Planning Committee

CB1, F2 and B2 (18/1678/FUL)

- Last presented to Planning Committee on 7 June 2020
- Adjourned Decision Protocol (ADP) engaged
- Two minded-to draft reasons for refusal
- Scheme revised and re-consulted upon
- Following extract slides from applicant's Design Document illustrating revisions and comparisons

5. Recess the north-western corner of block B2 to widen the pavement to 3.5m

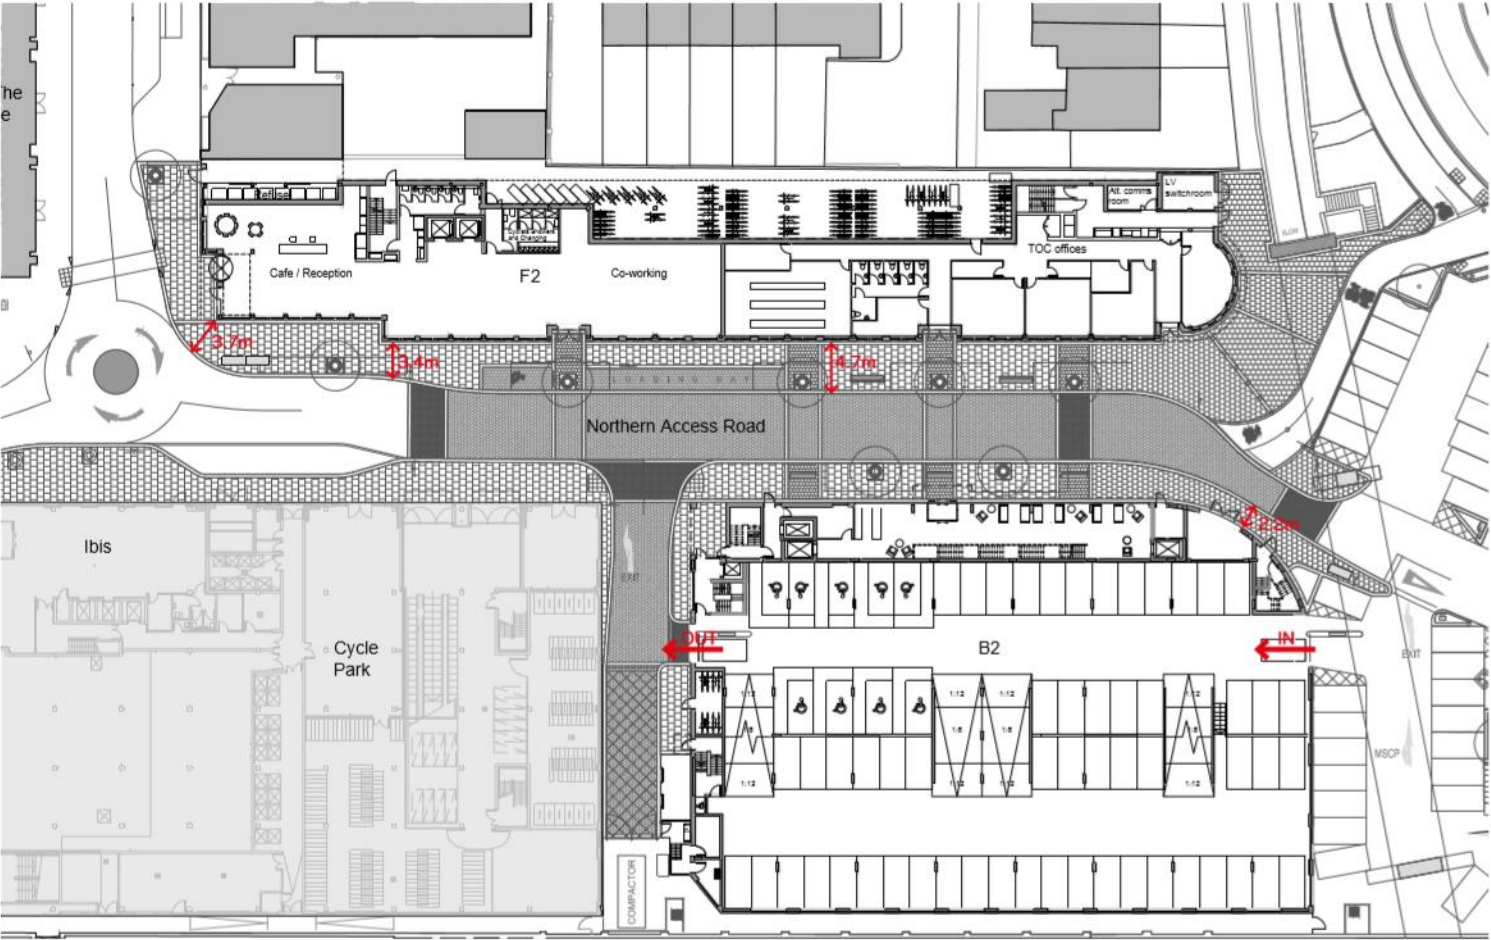
2. Loading bay adjacent to F2

Loading bay demarcation amended with the same paving treatment across the application to provide visual continuity of pedestrian priority.

3. Remove the blue badge parking bay on the pavement adjacent to F2

Scheme is policy compliant on the disabled parking requirement and ample disabled parking is provided located in the Station Square in immediate proximity. This can be **conditioned** if members require inclusion within the application.

4. Access and egress to the MSCP reversed to address potential conflicts

The MSCP is now proposed to be accessed from the southern entrance with cars exiting north of the building.

This will better integrate the flows of cycle and vehicular movements.

This will improve the pedestrian flow along the building and removal of the parking bay increases the usability and safety travelling north for pedestrians.

Increased Pavement Widths (close up)

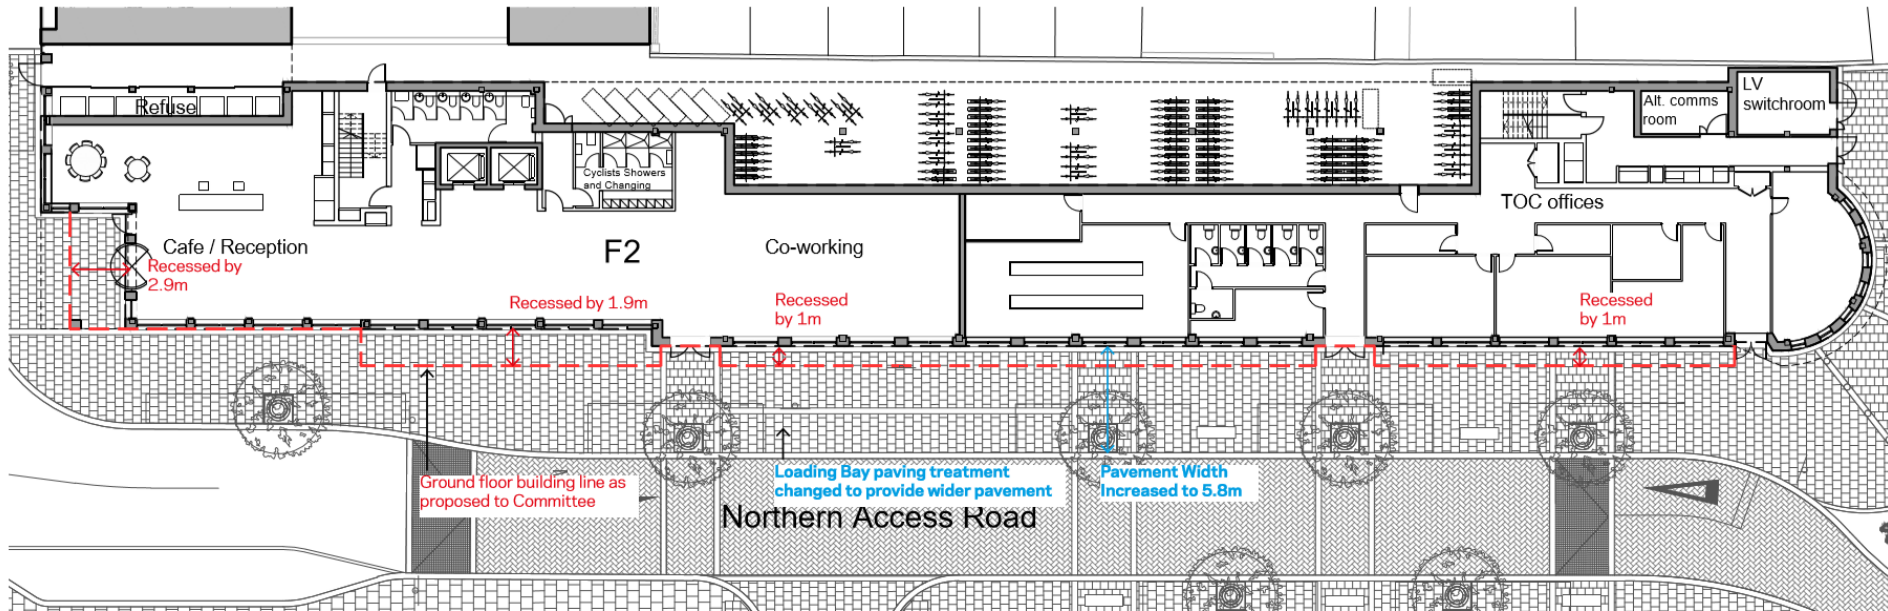
1. Increase the pavement width along block F2 to 5.2m and 5.8m

An increase by 2.9m at the junction with Great Northern Road and 1.9m and 1m along the Northern Access Road eases pedestrian movements along F2 and increases the streetscape physically and visually.

This is achieved by locally recessing the ground floor of F2.

Protected Future Route for the Chisholm Trail Access to the Northern Access Road

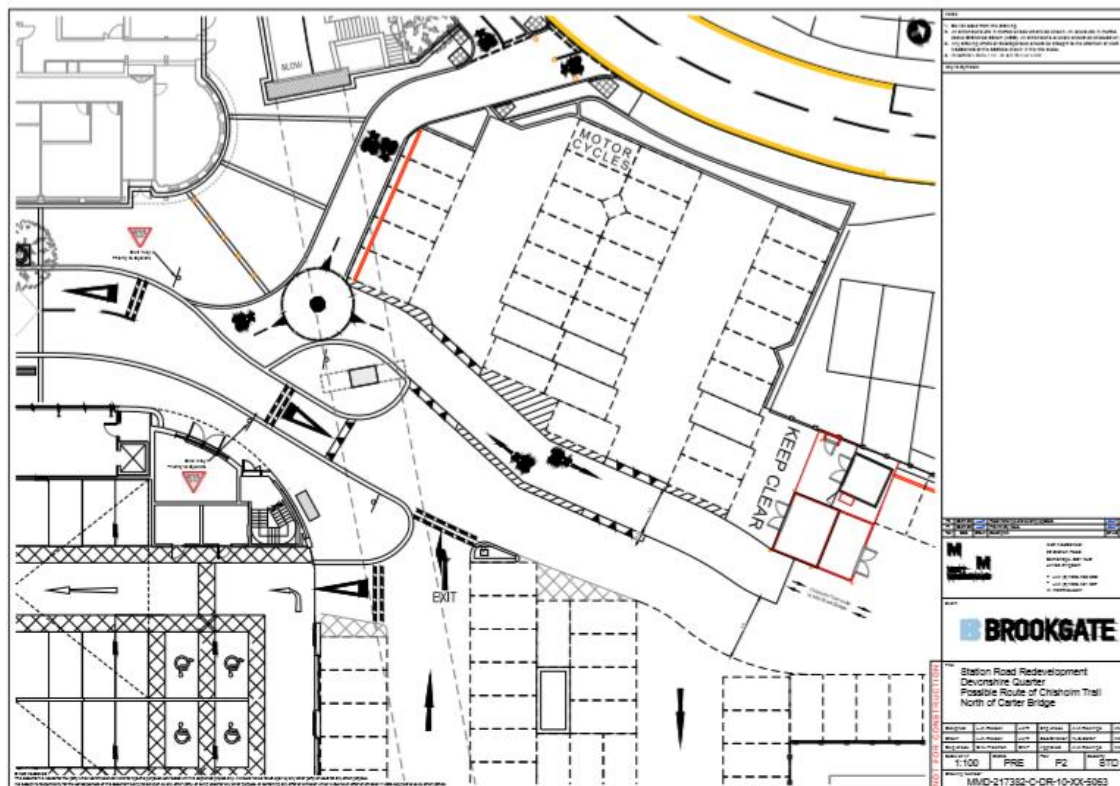
This application does not seek permission for any works related to the Chisholm Trail. Policy 80 is clear in its requirements that the route of the trail should not be prejudiced by development, the route around the Station and toward Devonshire Road is indicative and the County and other stakeholders have a number of legal and practical hurdles to overcome to deliver it. Brookgate have no control over that.

What our indicative plan shows is that the route is not prejudiced in any way, we are therefore policy compliant. The proposal protects the future inclusion of the Chisholm Trail.

It is also material that contributions from CB1 towards the trail now total £800,000, CB1 is therefore a positive contributor to the ultimate delivery of this route.

Comparison of the Consented and Proposed Footprint of Building B2

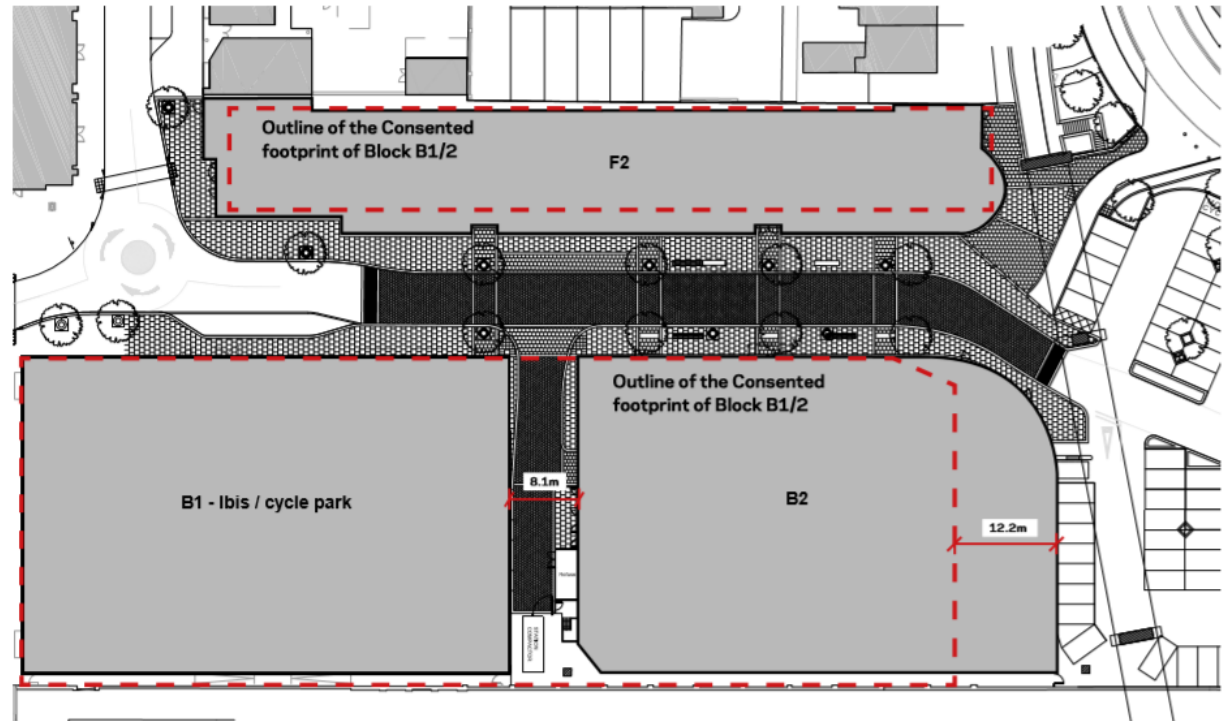
The below diagram compares the consented with the proposed footprint of building B2.

- An 8.1m gap between the Ibis and B2 enables light between the buildings, breaks up the length of the frontage and provides an outlook for the upper floor rooms
- This results in the proposed moving of the building north
- The proposed combined footprint is 17 sqm smaller than the consented footprint (consented: 4,227 sqm, proposed: 4,210 sqm)

Comparison of outline consent and proposed

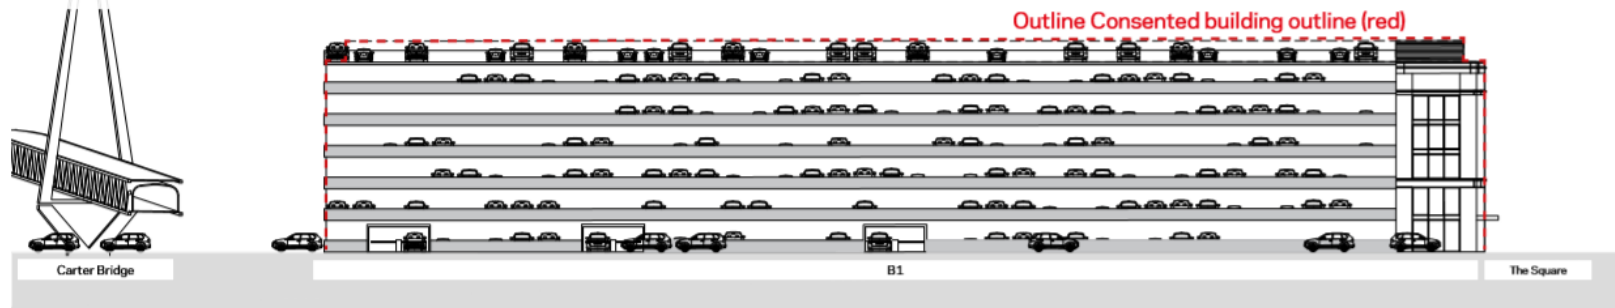
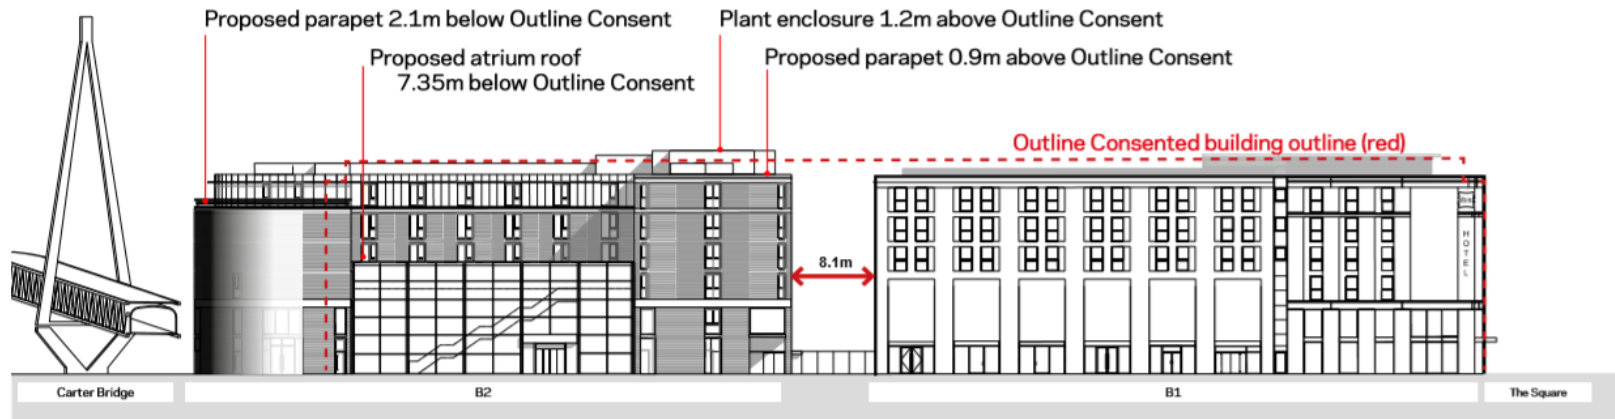
These drawings compare the consented and proposed length and height of Building B2. Whilst the building is closer to Carter Bridge it should be emphasised that:

1. The facade benefits from a significantly greater amount of animation than the consented car park facade would have delivered
2. The proposed active frontage delivers a significantly safer and more animated street scene than the blank car park facade would have delivered
3. The break between B1 and B2 permits views and light between the two buildings compared to the 110m long facade of the consented car park
4. The building height steps down towards Carter Bridge and the atrium opens up the street to light and views

Comparison of the Consented Building B1 only with the Proposed Building B2 Looking South along Devonshire Road

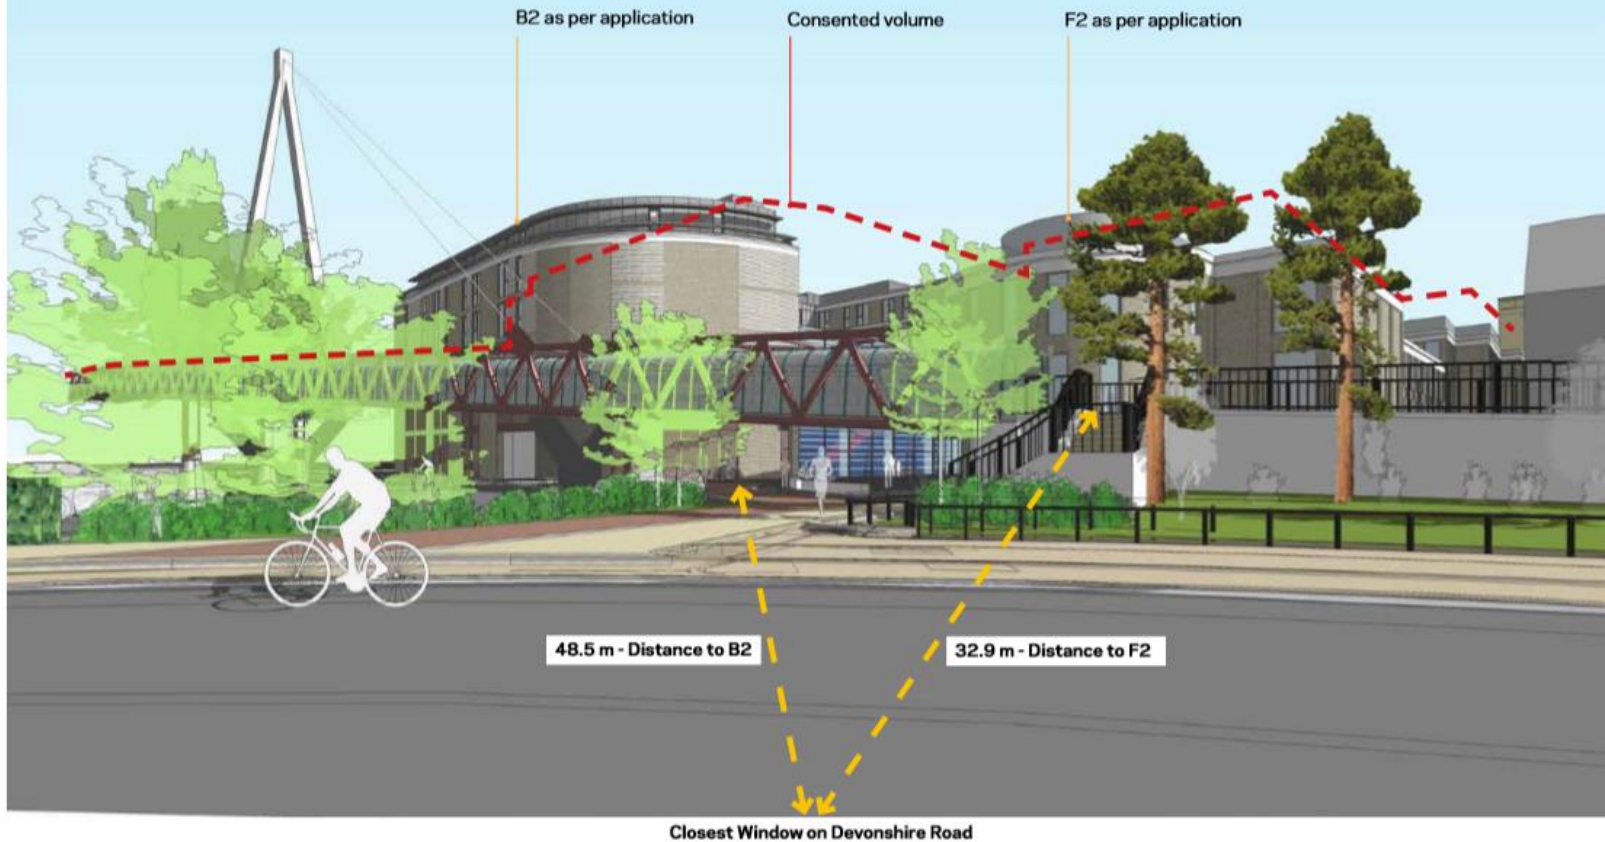
This comparison illustrates that the repositioned block B2 has no negative impact on the view south along Devonshire Road:

- The reduction of visible sky and horizon due to the proposed relocation of B2 is negligible

- Proposed Block B2 is **48.5m** from the closest property on Devonshire Road: **4.7m** closer than consented.
- Proposed Block F2 is **32.9m** from the closest property on Devonshire Road: **1m** further away than consented.
